SUBJECT: City of Wilsonville Plan Amendment  
DLCD File Number 001-10

**AN ORDINANCE OF THE CITY OF WILSONVILLE AMENDING THE VILLEBOIS VILLAGE MASTER PLAN TO RELOCATE THE PLANNED ELEMENTARY SCHOOL FROM THE NORTH SPECIFIC AREA PLAN (SAP) TO THE EAST SPECIFIC AREA PLAN (SAP) WITH ASSOCIATED MAP AND TEXT MODIFICATIONS.**

Attachment 2: Planning Commission Recommended *Proposed Legislative  
Amendment Villebois Village Master Plan (case file no. LP10-0001)*

## PROPOSED LEGISLATIVE AMENDMENT VILLEBOIS VILLAGE MASTER PLAN (City File No. LP10-0001)

Figure 7

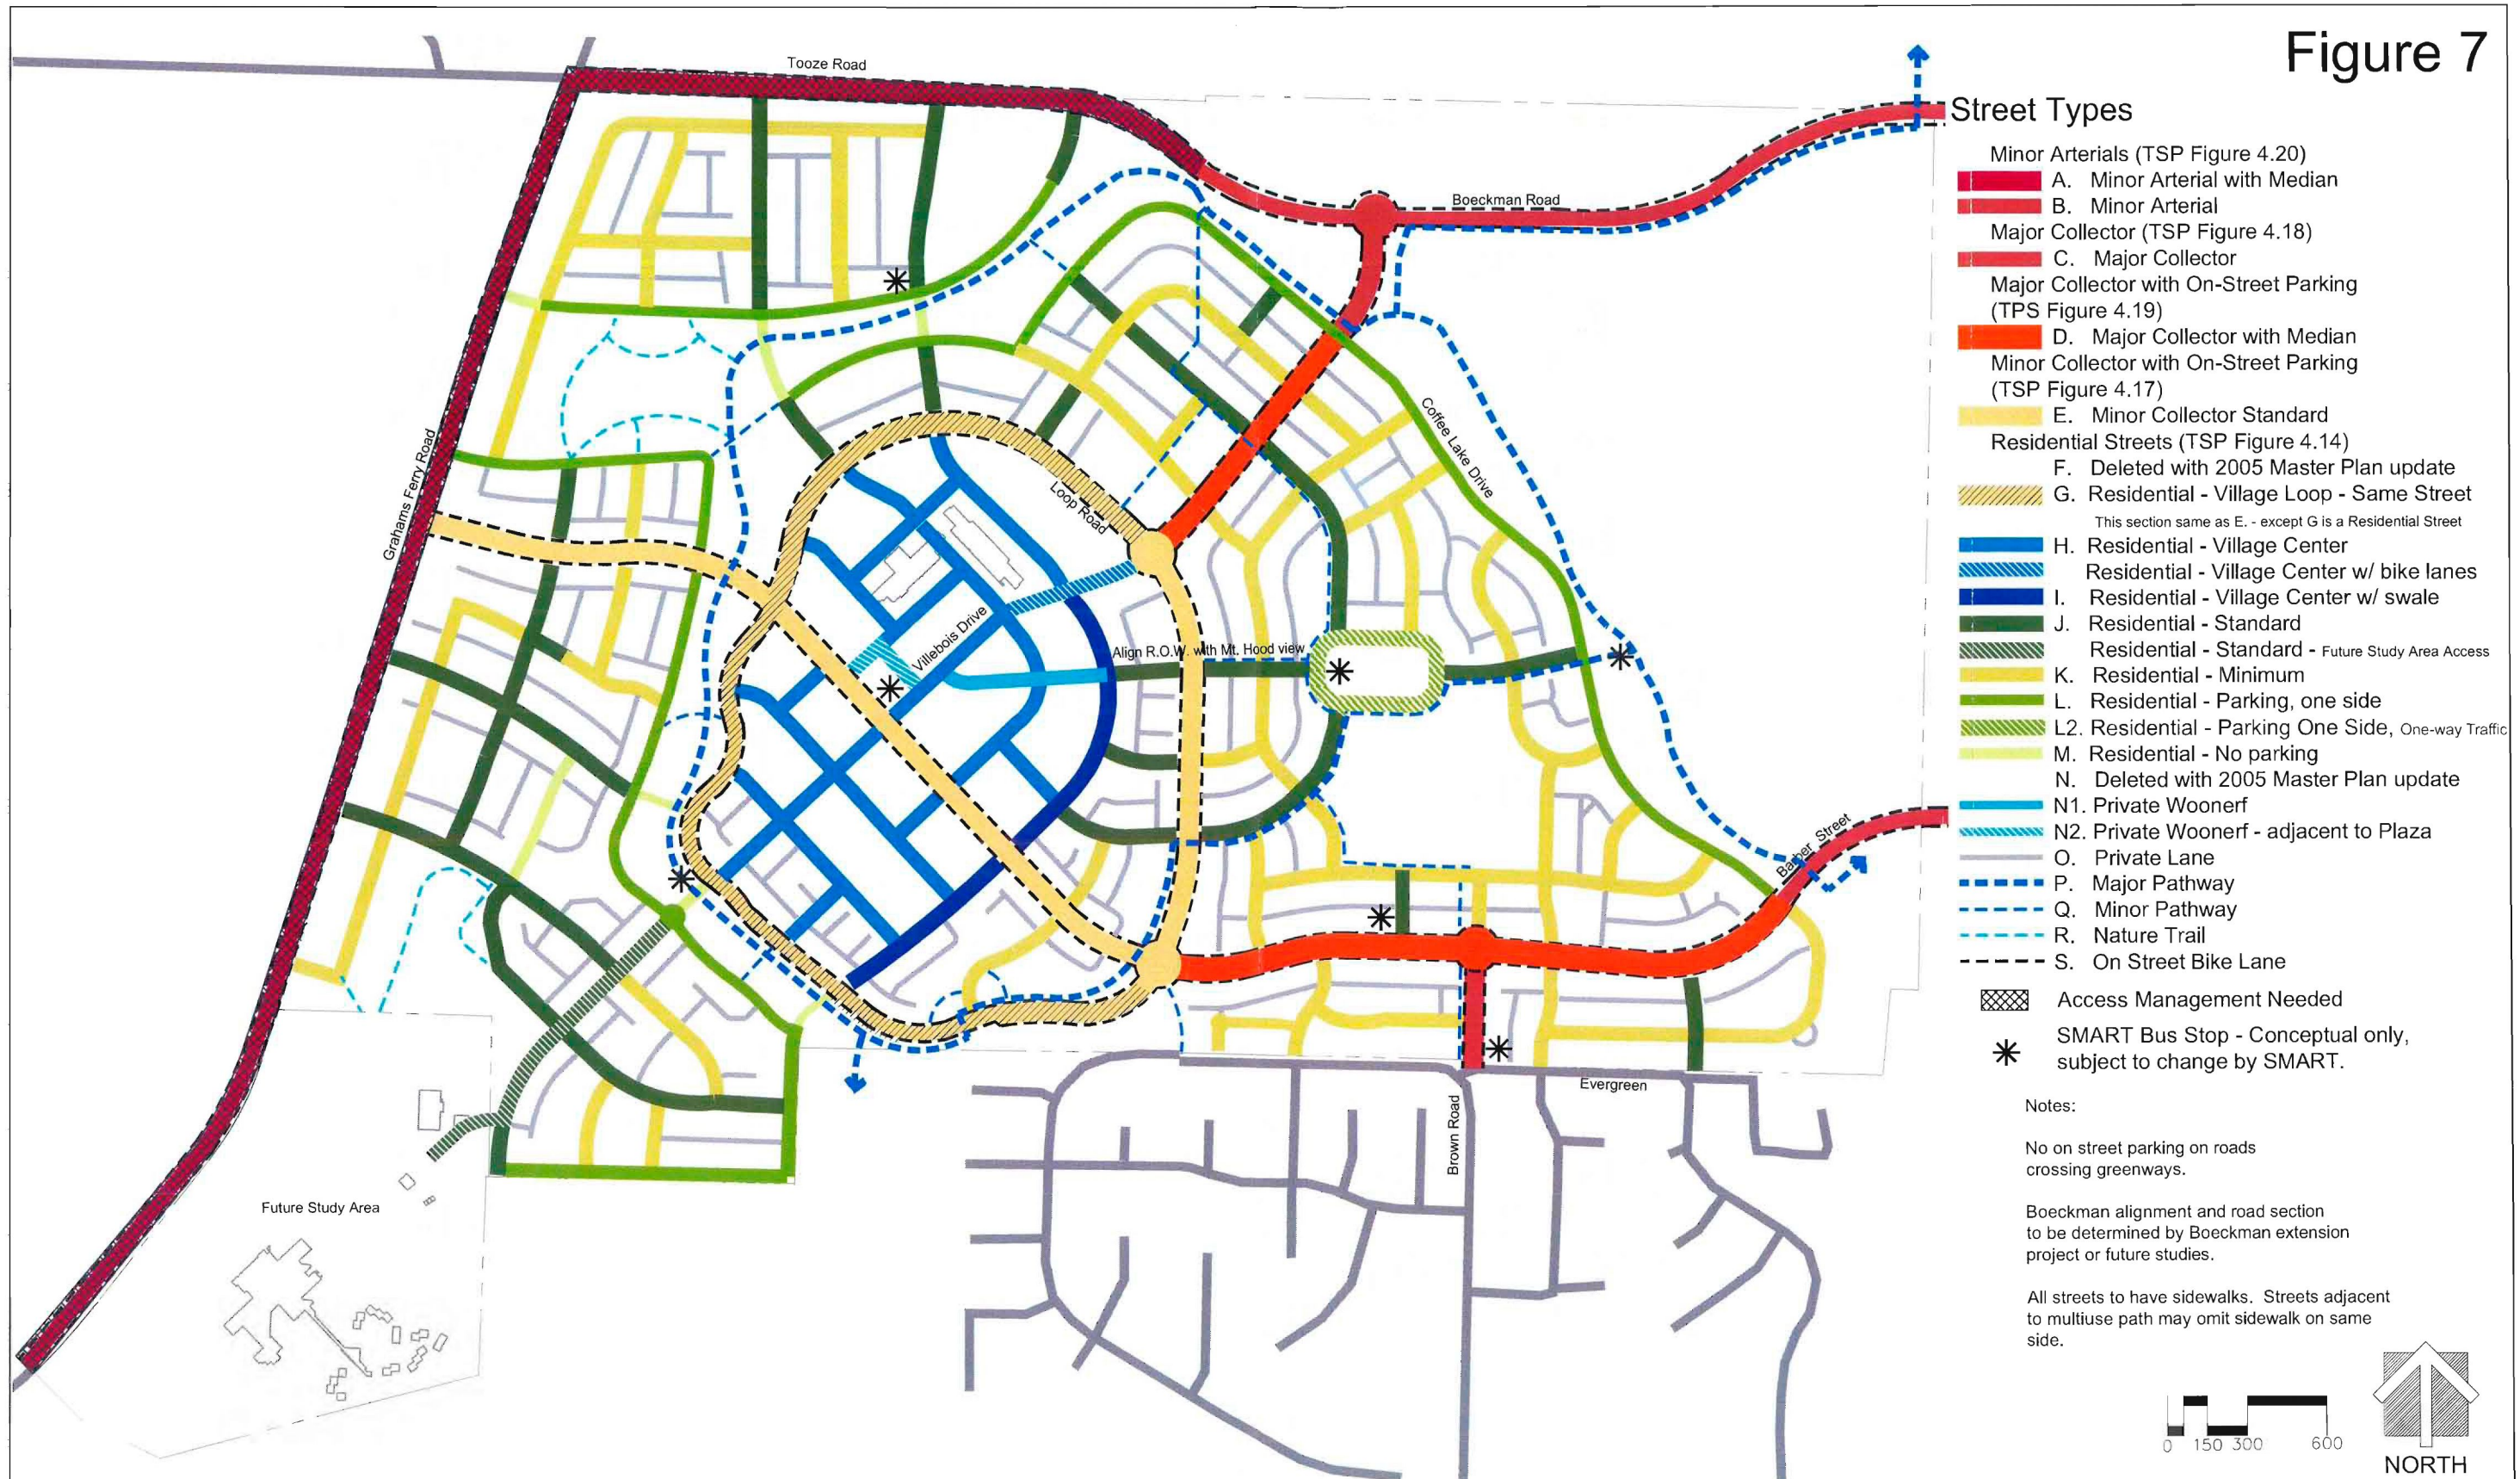
- **Figure 7 – Street Plan** has been modified to show the new residential streets and alleys in the north to accommodate residential development and the associated deletion of the street grid in the east where the new school is proposed. The addition of one-way circulation around East Park along Carinthia Circle has been added as a possible option to enhance student and pedestrian safety. No other changes to the street grid or road hierarchy are proposed.

It has come to my attention that there were some errors in the original mapping in terms of the street designation for Brown Road north of the roundabout. Exhibit 9 – Figure 7: *Street Plan* of our original April 23, 2010 submittal identified Brown Road as a “Residential – Minimum” street. I was informed that the Intergovernmental Agreements with the West Linn Wilsonville School District describe this section of Brown Road as a “Major Collector with Median.” The cross section for that designation includes a bicycle lane thereby necessitating a change to Exhibit 5 – Figure 5A: *Recreational Experiences Plan* and Exhibit 11 – *Technical Appendix: Recreational Opportunities & Experiences* to include on-street bicycle lanes. Please accept the attached maps to reflect the appropriate changes.

Figure 9B

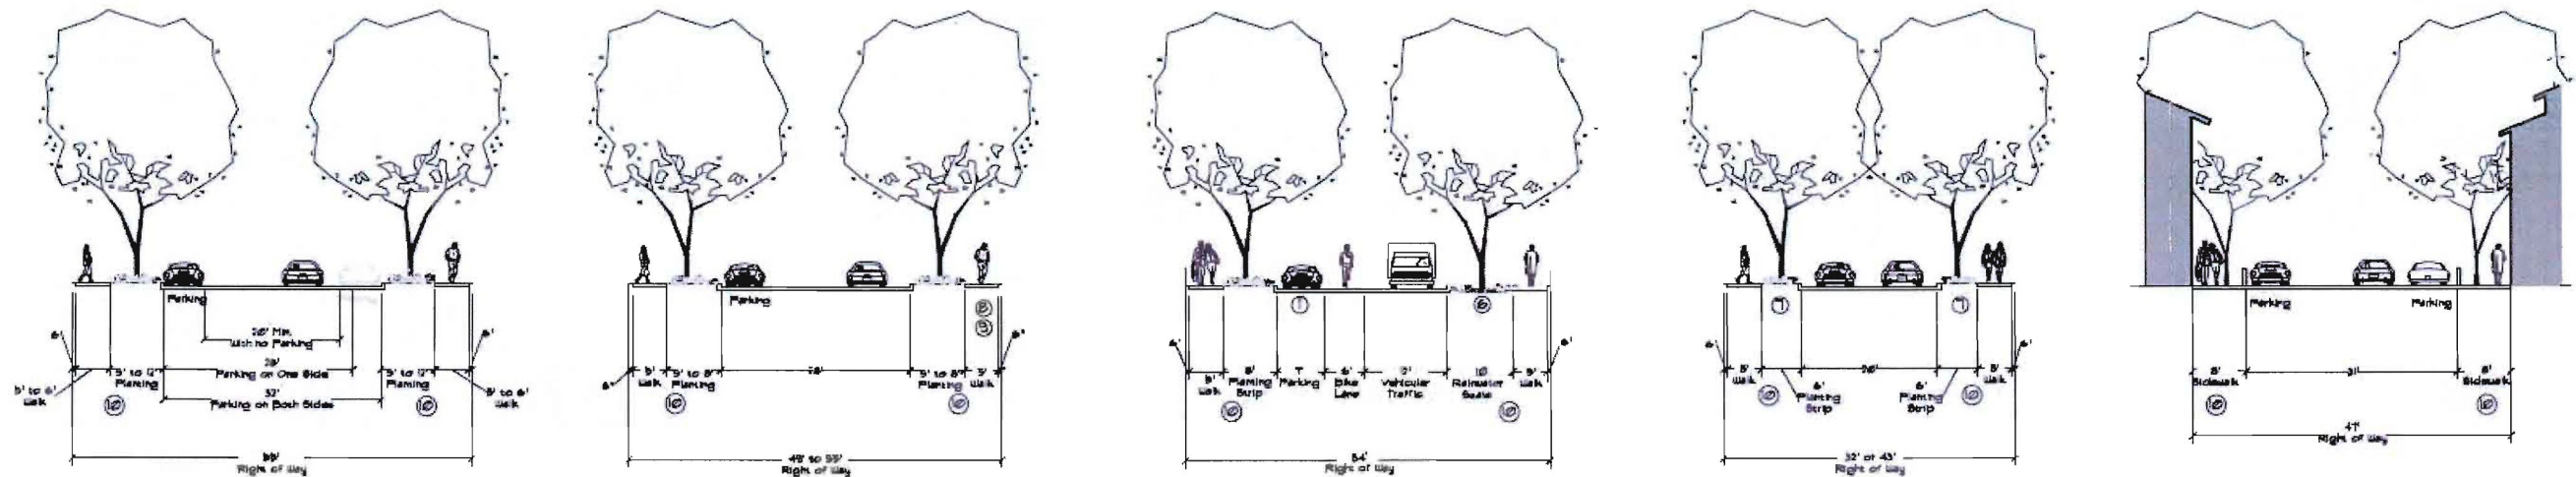
- **Figure 9A and 9B – Street and Trail Sections – A/B.** A new one way residential street is proposed to be added to the street hierarchy, which would allow for one-way flow with parking on one side and on-street bicycle facilities, off set sidewalks with street trees at a 54' ROW. This street could be used as a design option around East Park to reduce vehicle and pedestrian conflicts and to reduce the distance from the park to the school calming traffic and enhancing student safety.
